## REMARKS

Claims 1-30 are pending and stand rejected. Applicants have amended claims 1-5, 7, 23, 26 and 28.

**FIG. 3**

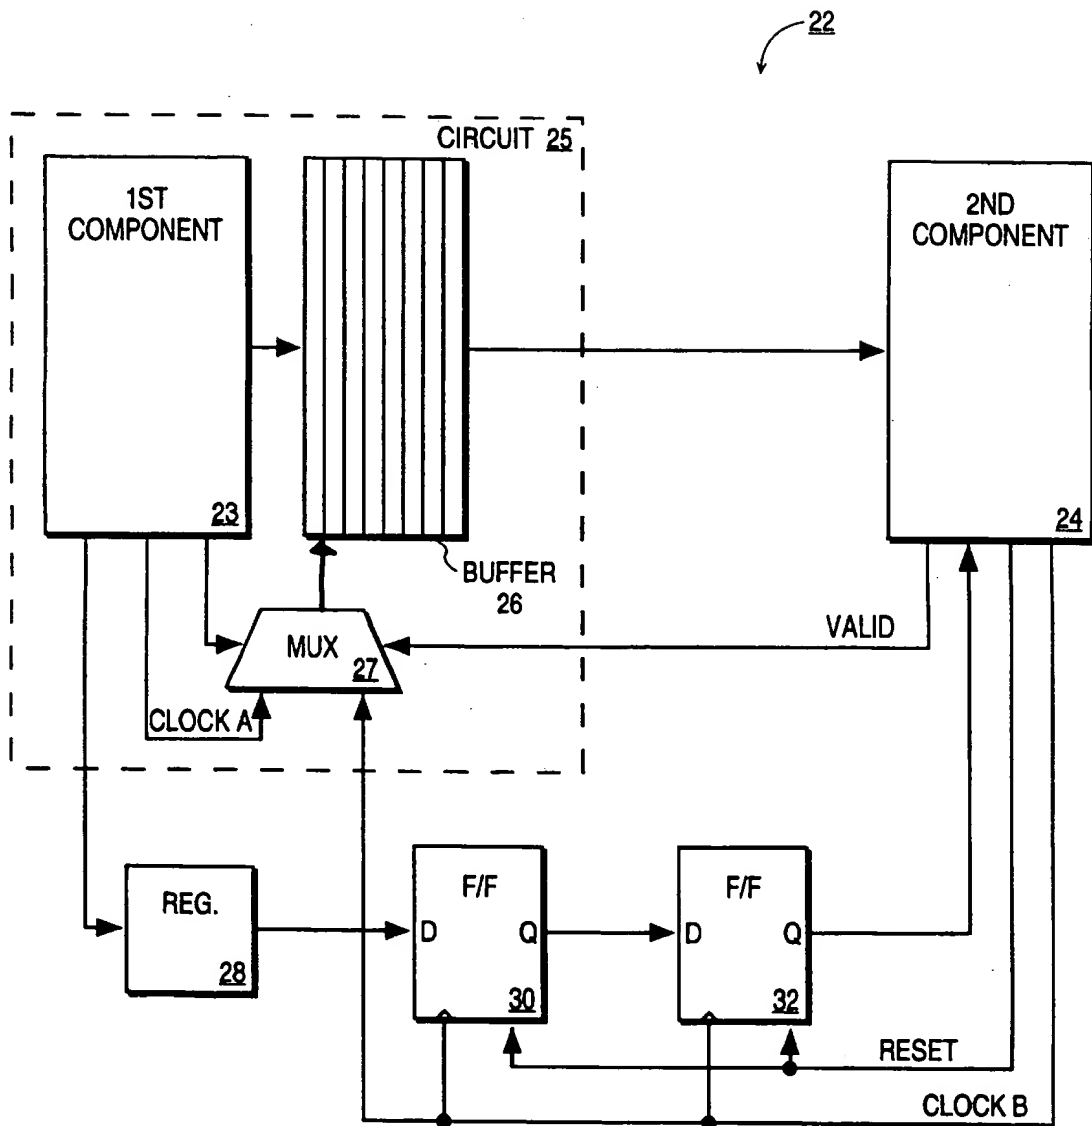
Applicants are hereby amending FIG. 3 to make it consistent with the specification (col. 5, lines 60-61). A redlined copy of FIG. 3 is enclosed herewith. The Examiner is asked to approve this change to FIG. 3.
